Historic Preservation Commission

Wednesday, April 8, 2026

ZHPC-0126-000003 - 1076 Canton Street - Certificate of Appropriateness for a change to the proposed partial demolition plan

CITY OF ROSWELL, GA PLAN CONDITIONS REPORT (ZHPC-0126-000004)

TREE PLAN

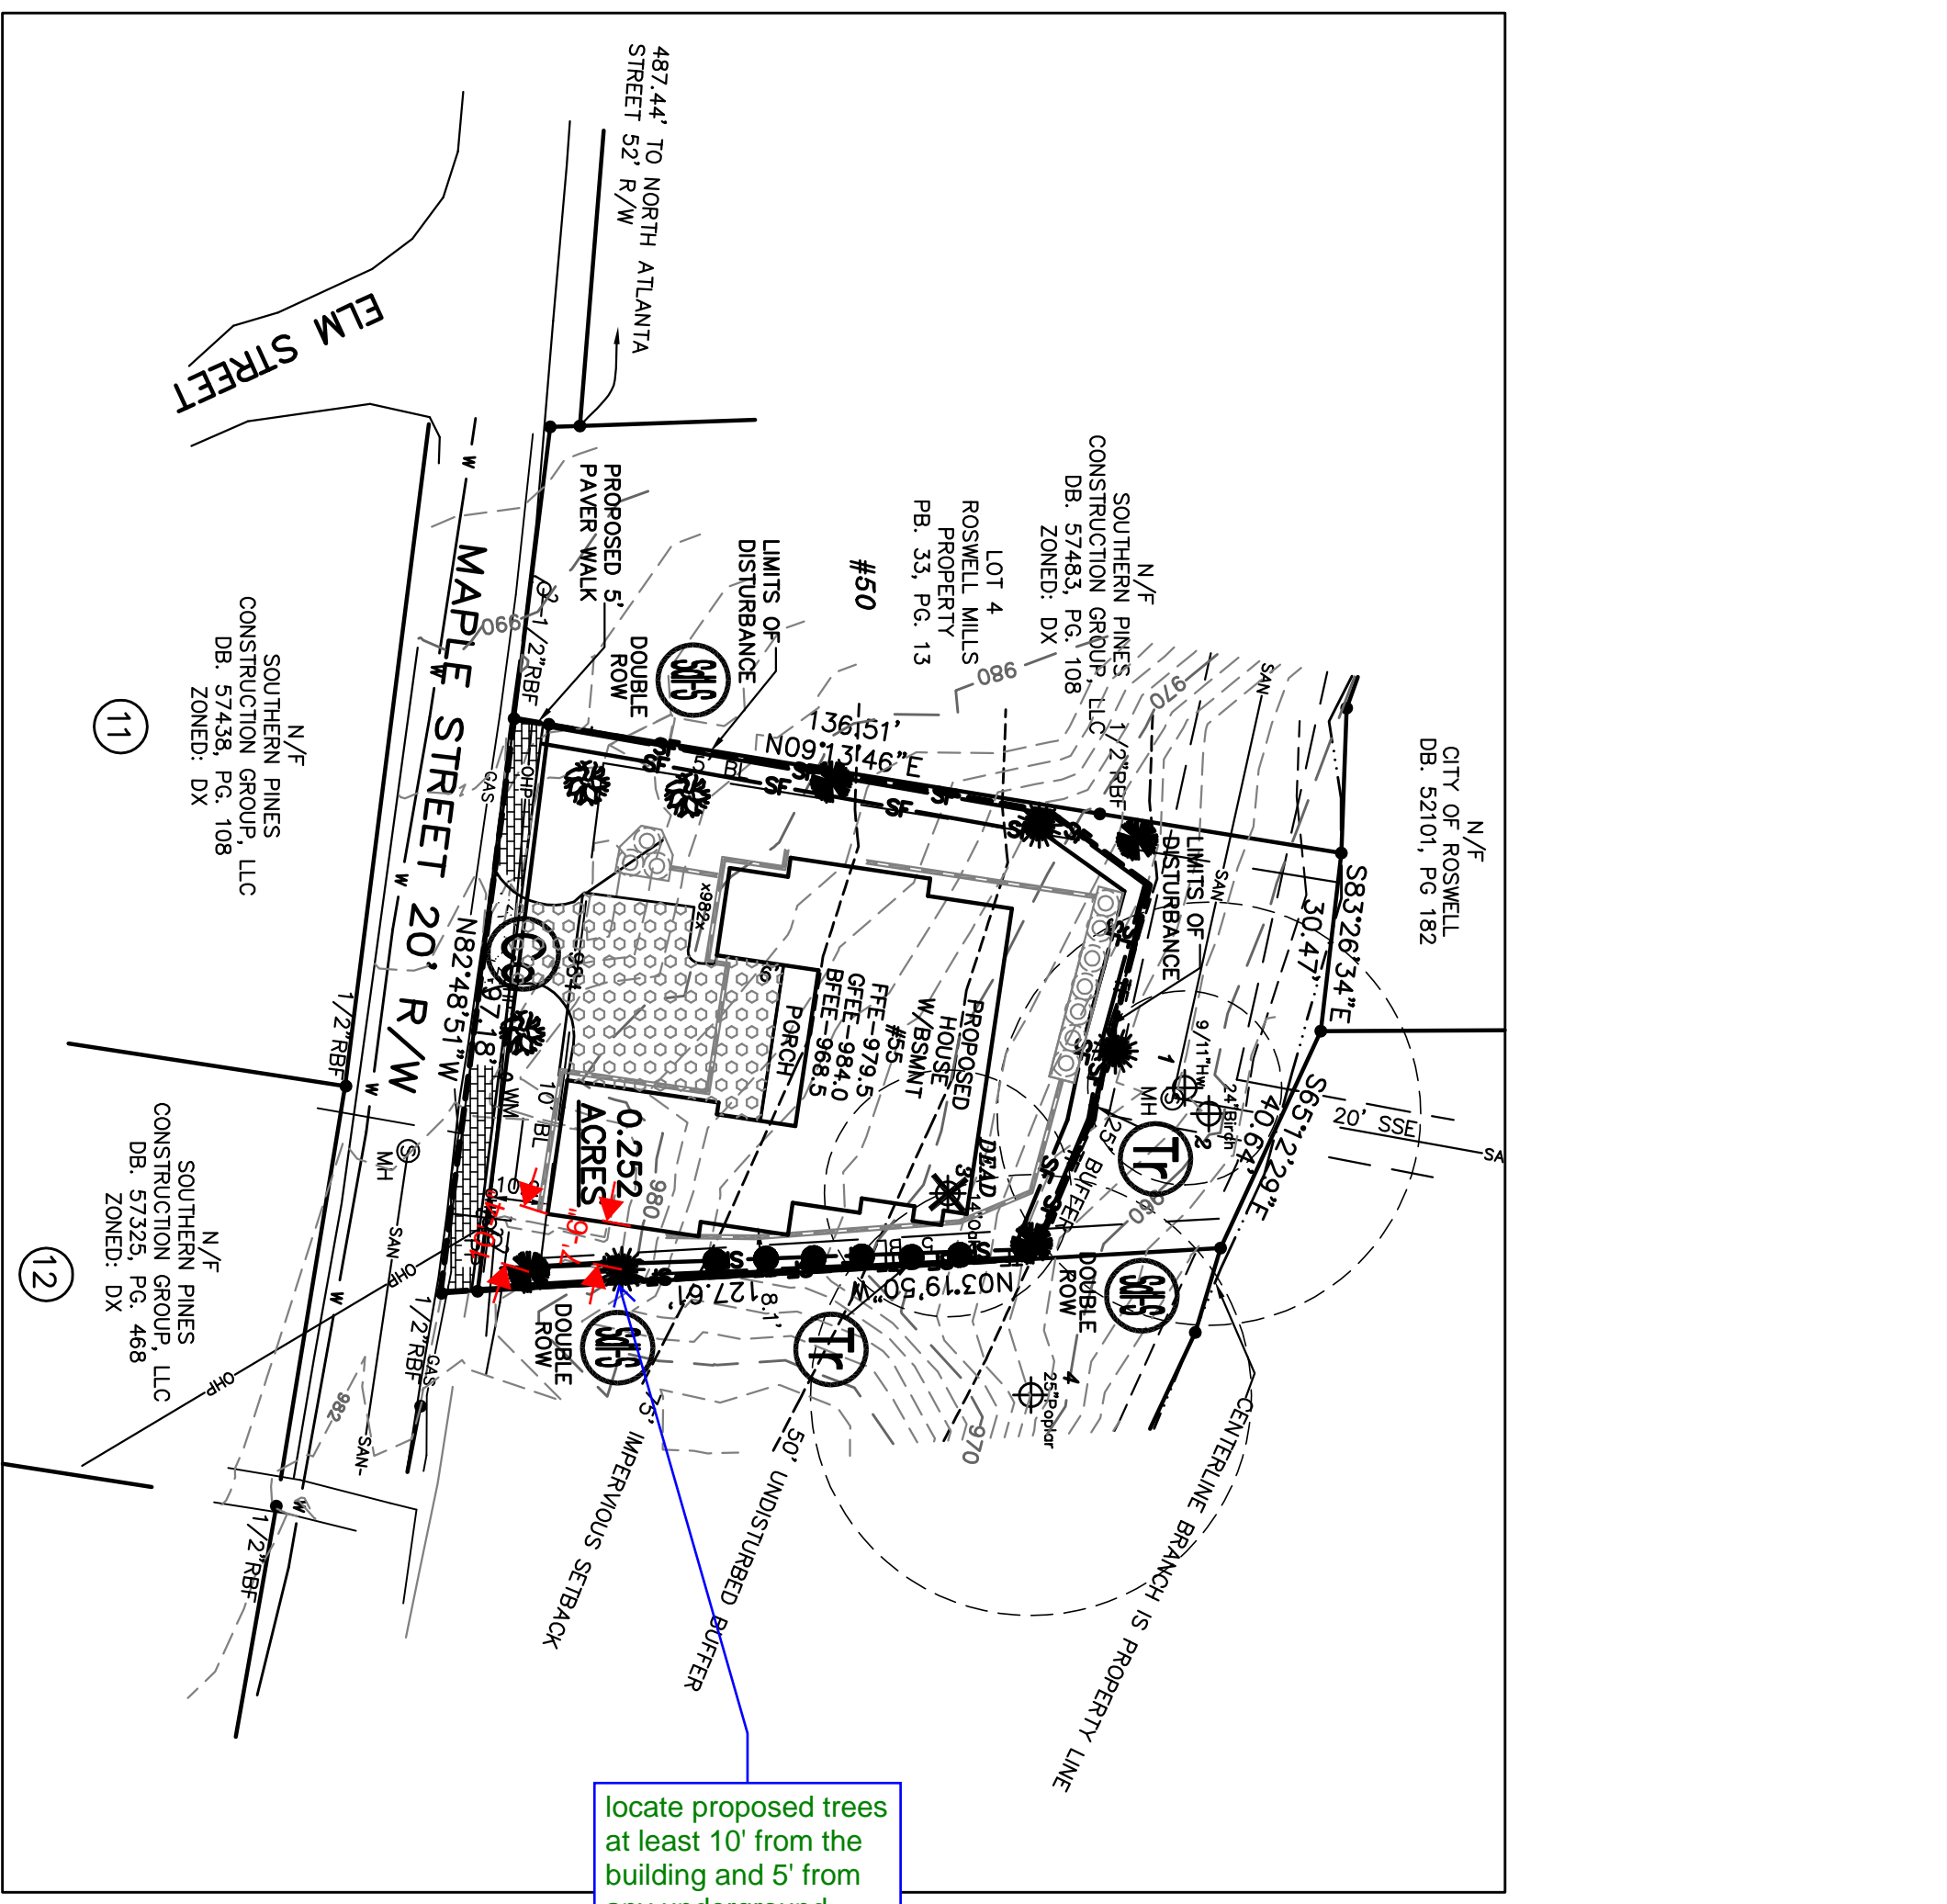
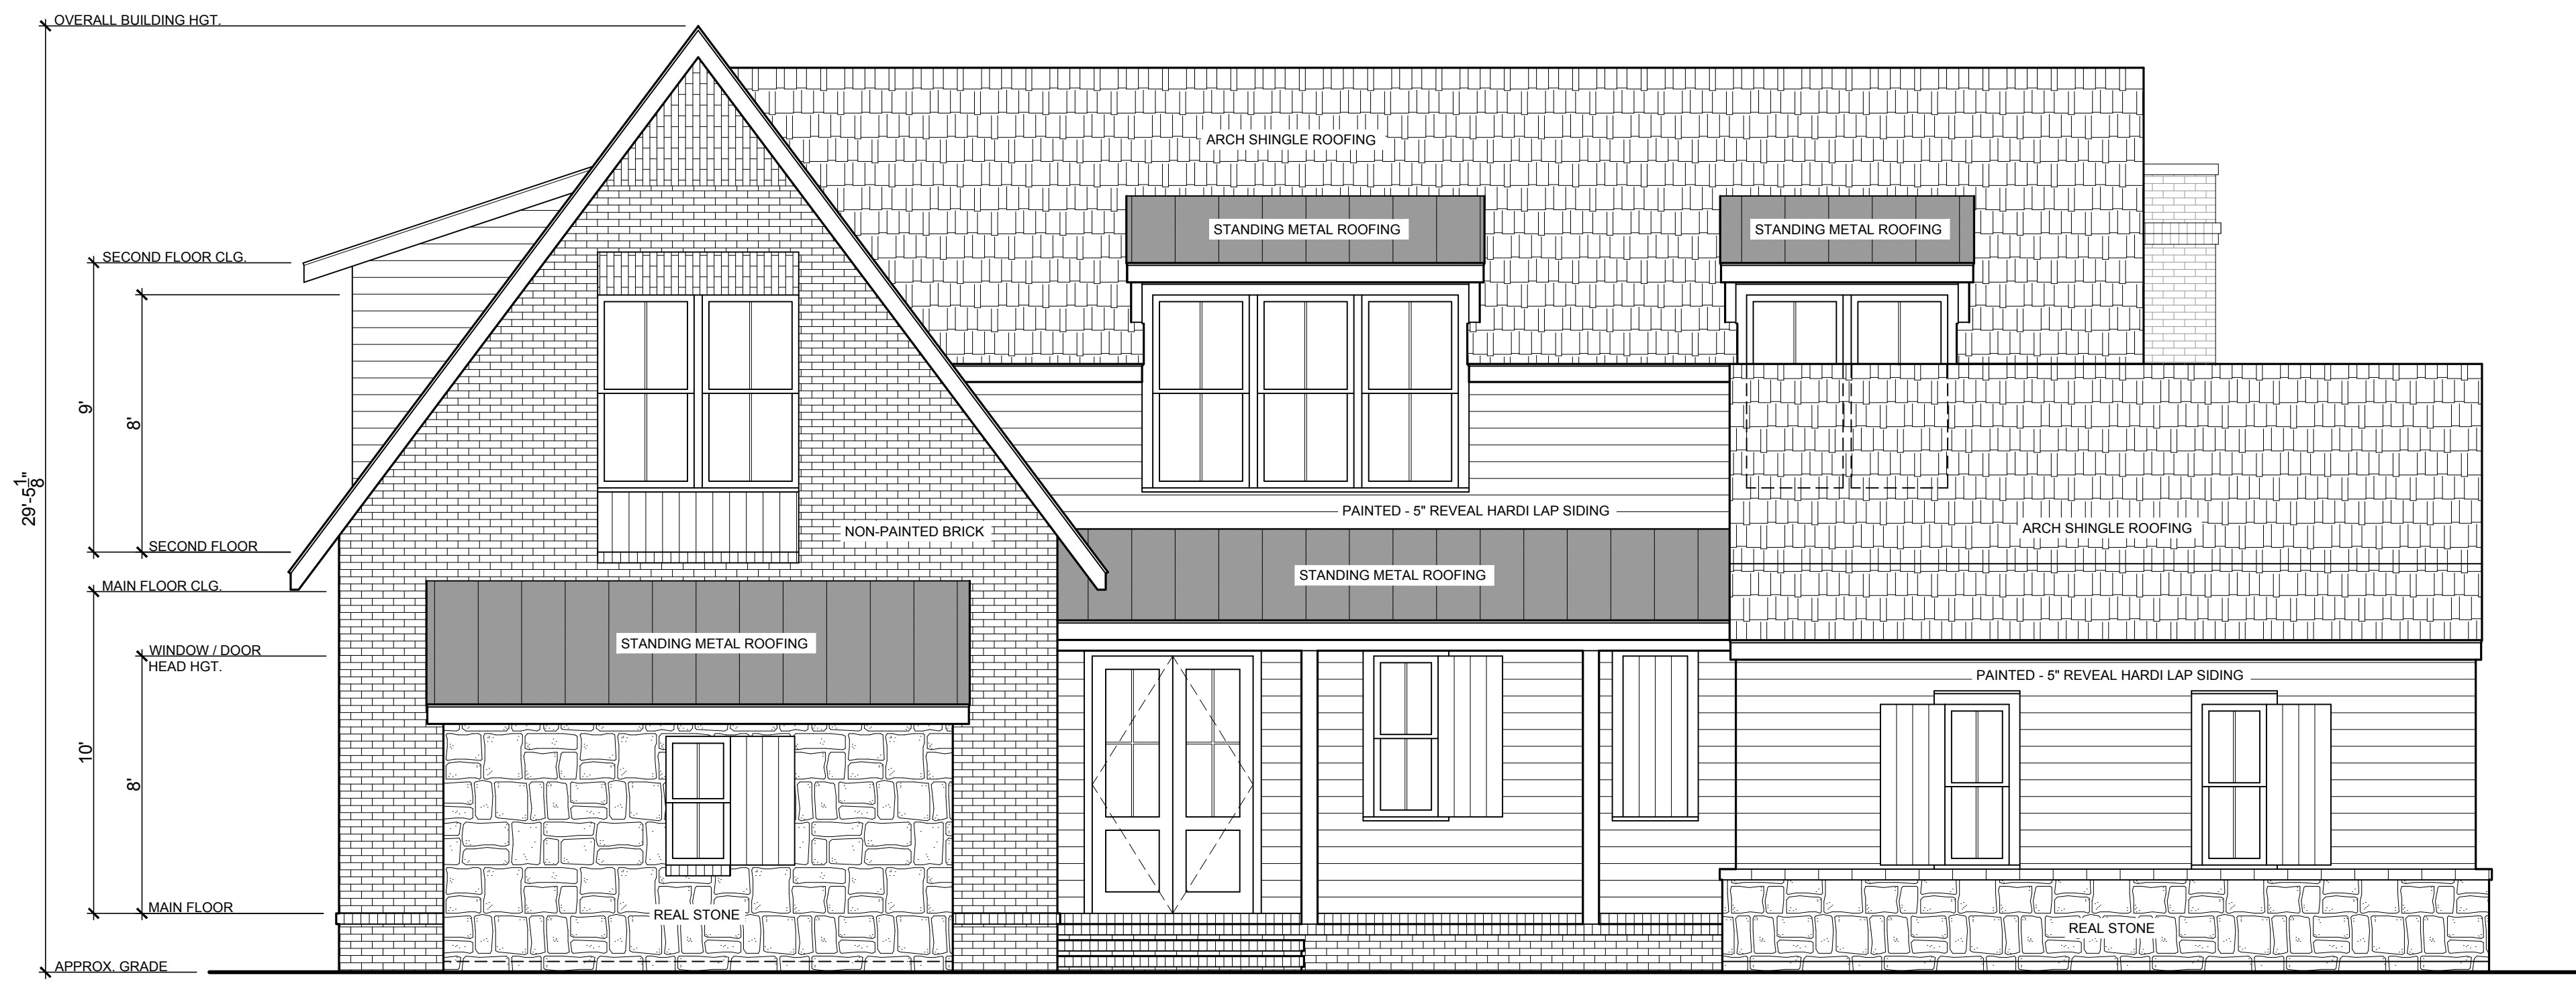
Correction: Tree Plan - Laura Sommet(3/2/26)Not Resolved

During LDP, show plant schedule with trees by species (scientific and common), quantity, height, size, spacing, and any special notes

A01

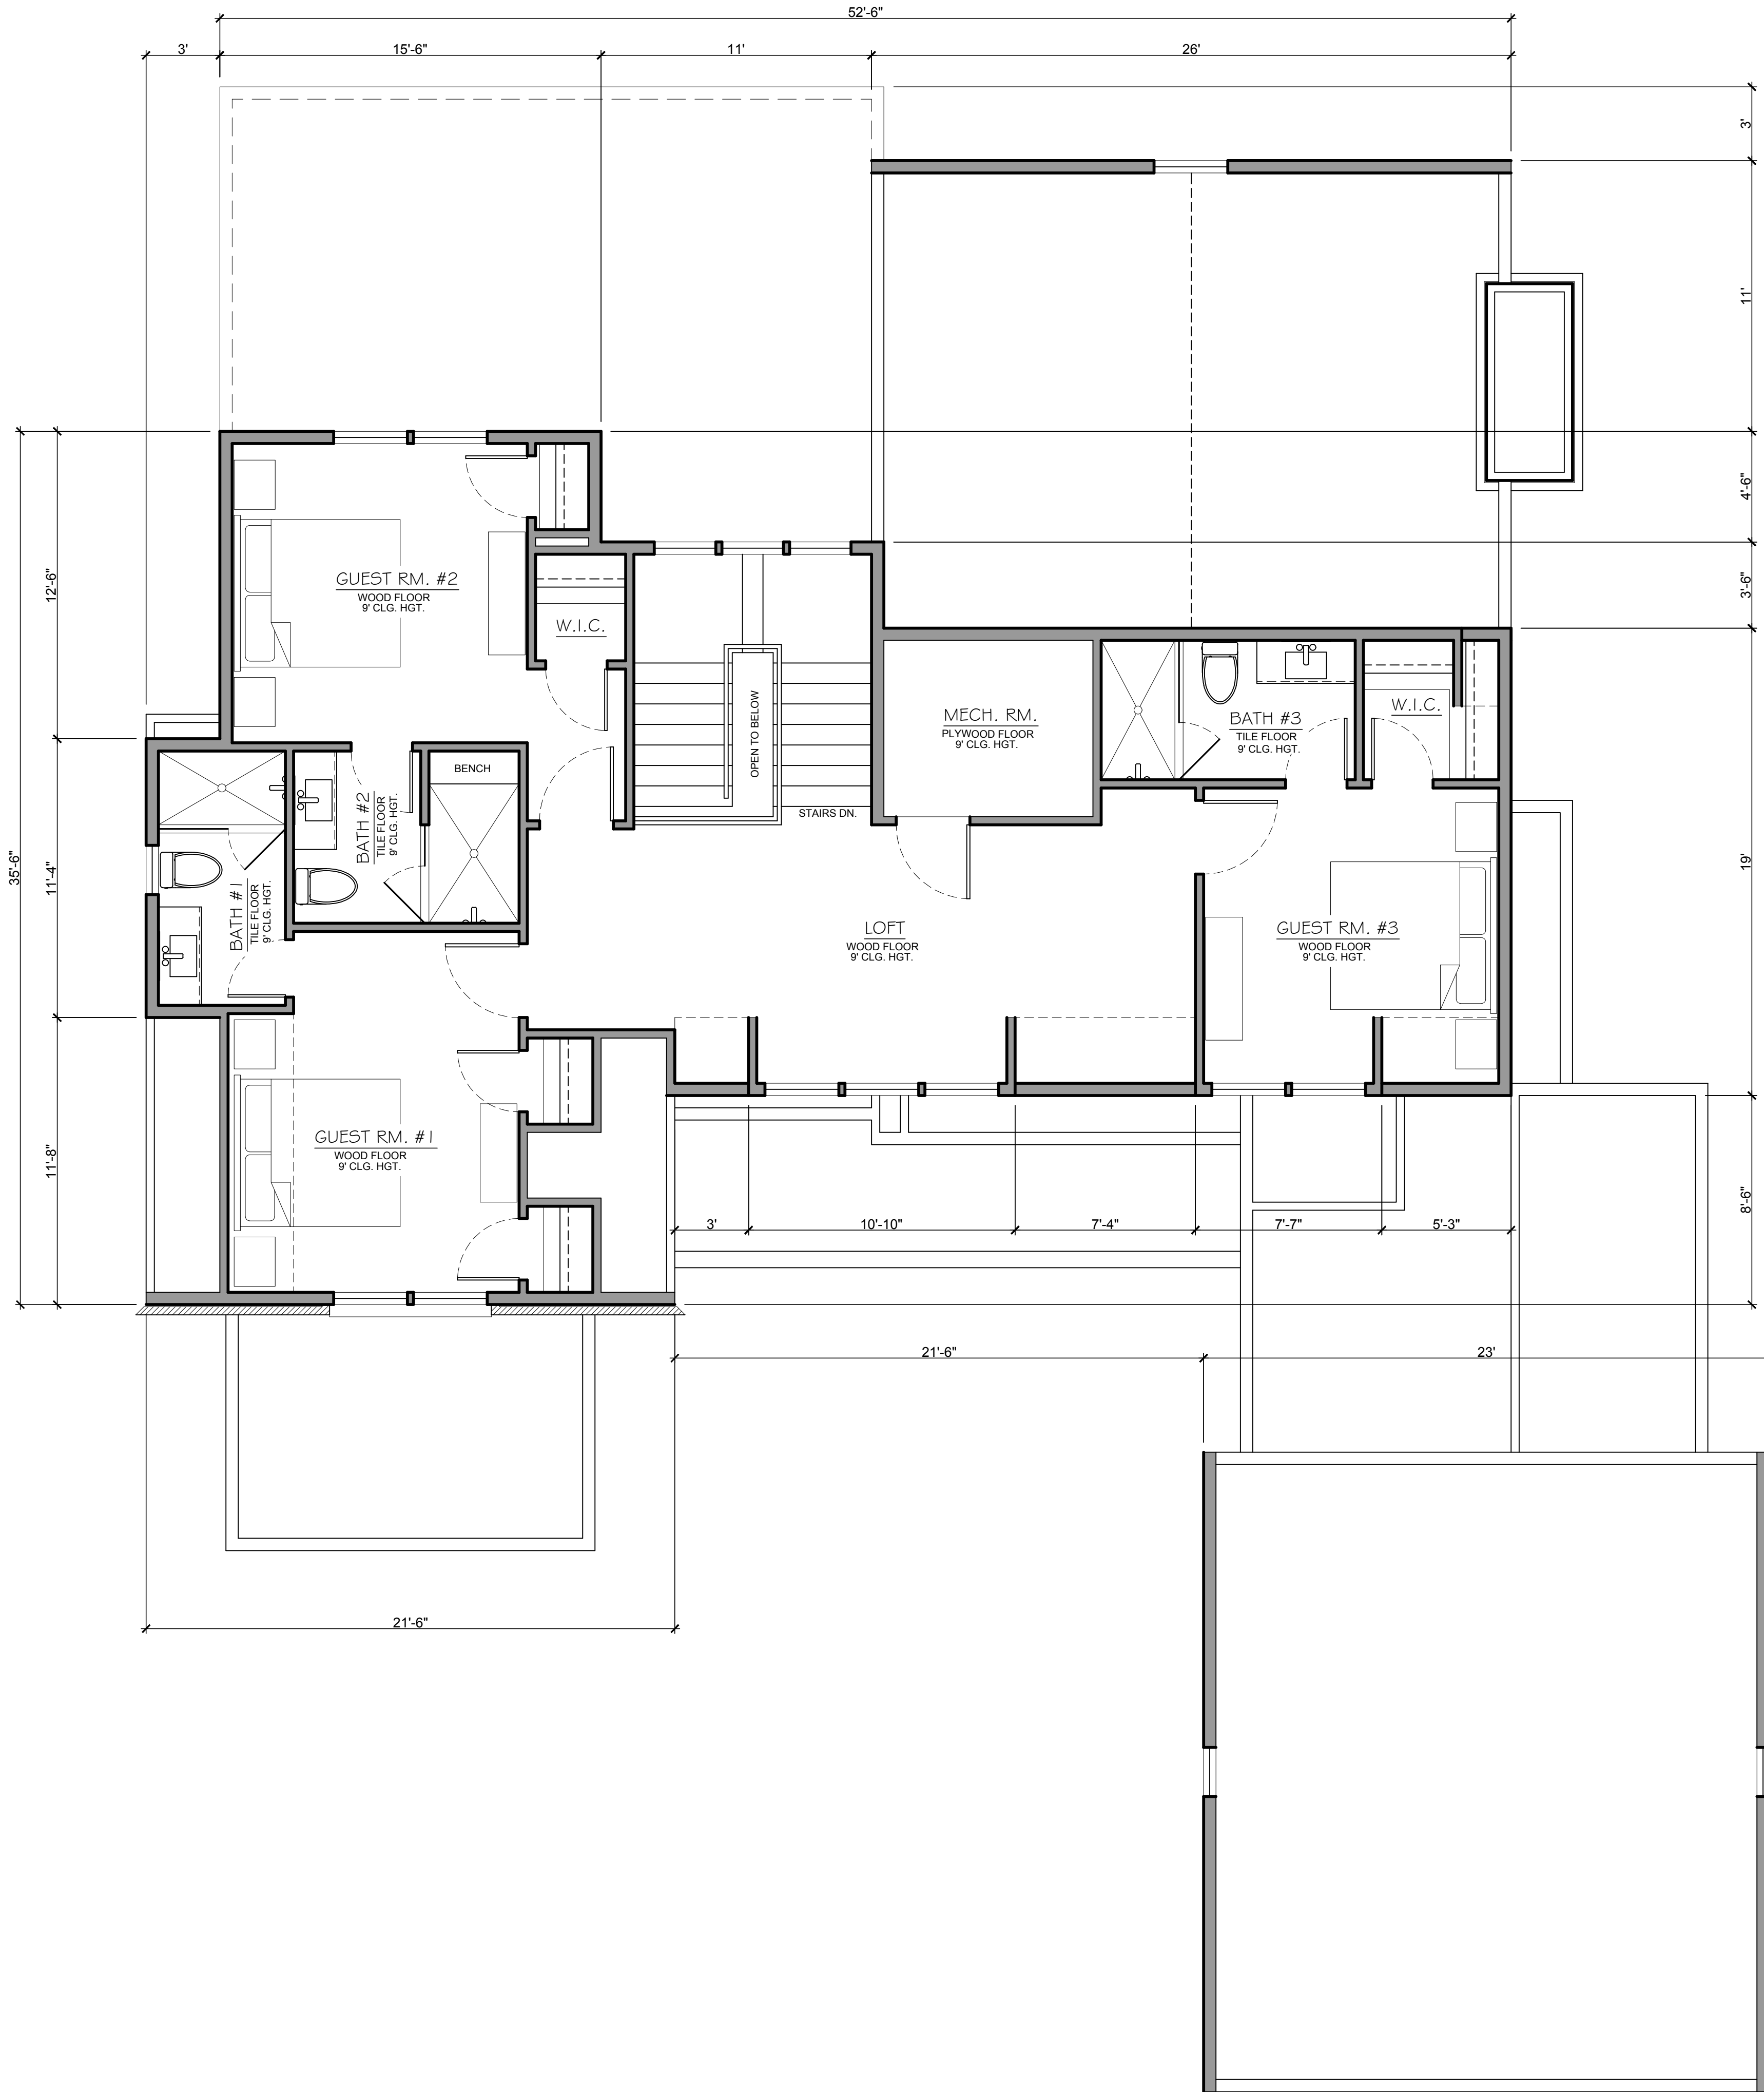
Comments: B. Fireplace is shown on floor plan (as shown on sheet A01), but not on site plan. Cannot determine if this affects encroachment into the side setback.

Comments: B. Fireplace is shown on floor plan (as shown on sheet A01), but not on site plan. Cannot determine if this affects encroachment into the side setback.
